8. Well Name and No.
SD EA 29 FED COM P8 12H9. API Well No.
30-025-43271-00-X110. Field and Pool or Exploratory Area
WC025G06S263319P-BONE SPRING11. County or Parish, State
LEA COUNTY, NM**SUBMIT IN TRIPLICATE - Other instructions on page 2**

CHEVRON respectfully requests the ability to change the BOPE rating for the subject well, from a 5M system to a 10M system while drilling the production sections that penetrate the Wolfcamp formation. (All intermediate sections, which TD in the Bone Spring, will have the previously submitted 5M system setup).

BLOWOUT PREVENTOR SCHEMATIC

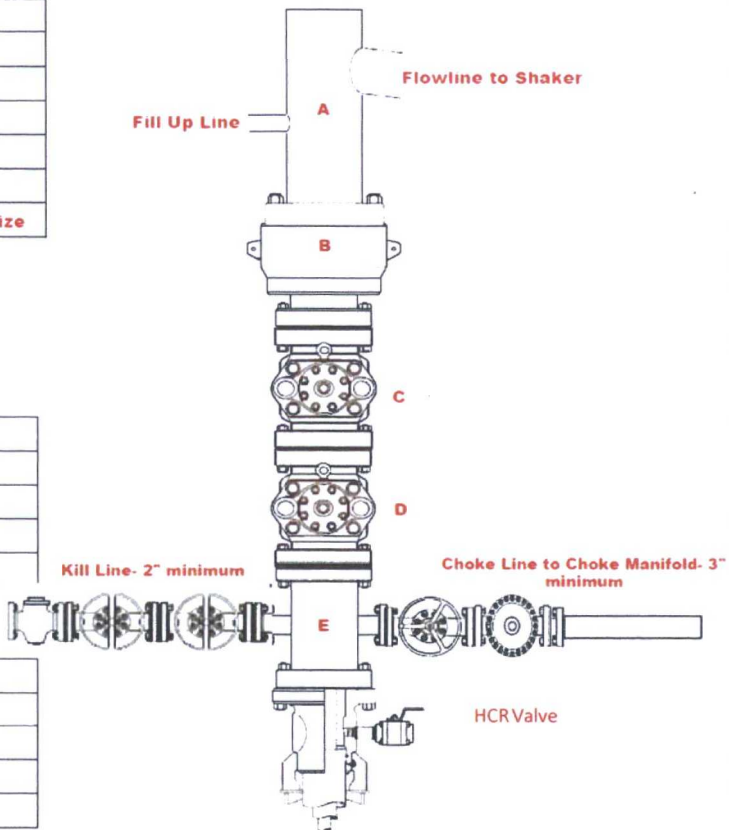
** BLM REVISED ** BLM REVISED ** BLM REVISED ** BLM REVISED ** BLM REVISED **

CHOKE MANIFOLD SCHEMATIC

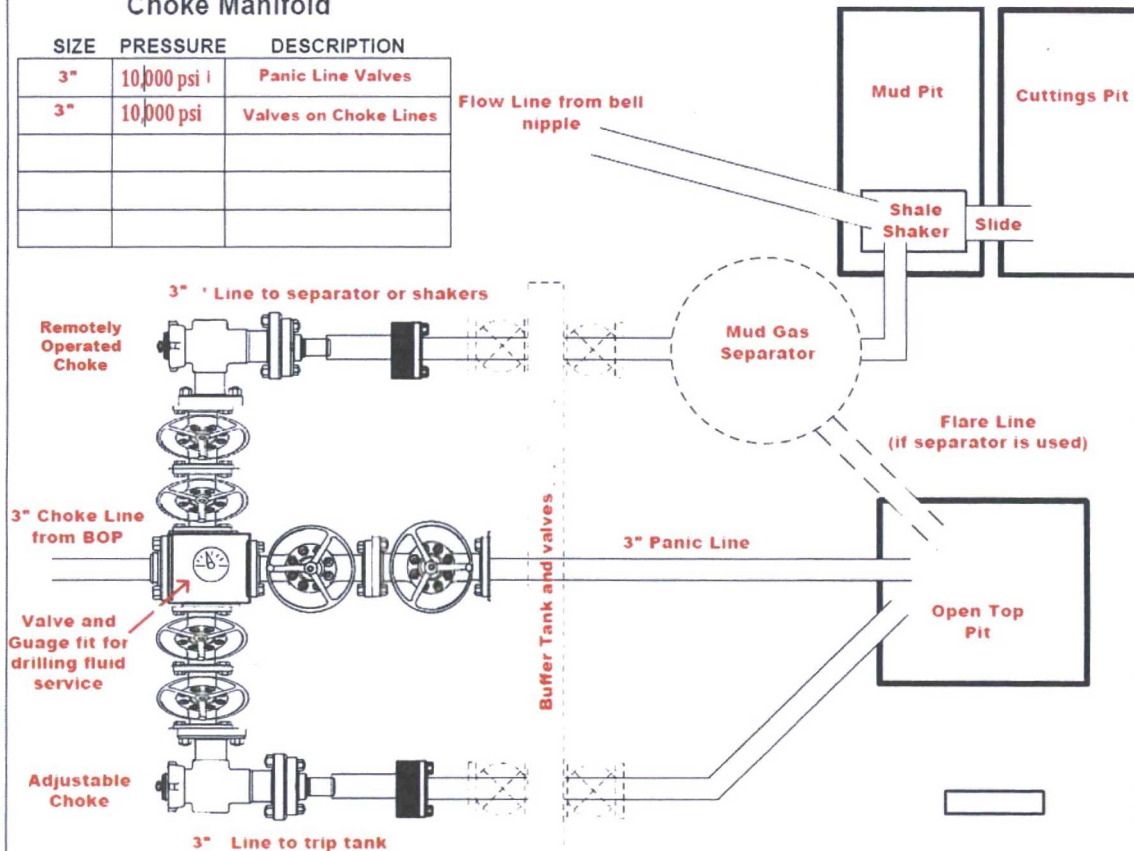
*All equipment will be 5M as per the original submittal, but the annular will be 10M, as well as the necessary upgrades to the choke manifold. (Upgrade 2" choke lines to 3" with a third choke).

10M Choke Manifold SCHEMATIC

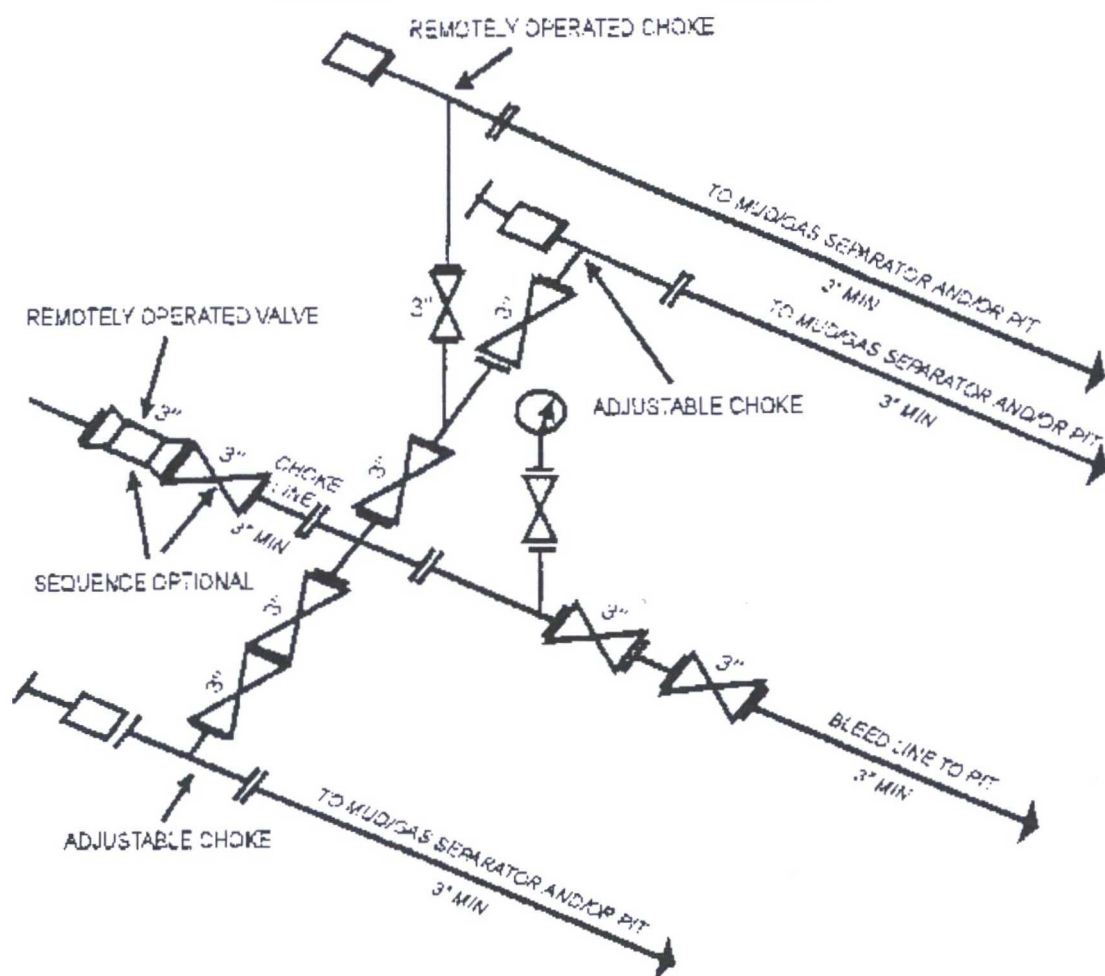
Please find attached, the 10M BOP choke schematic.
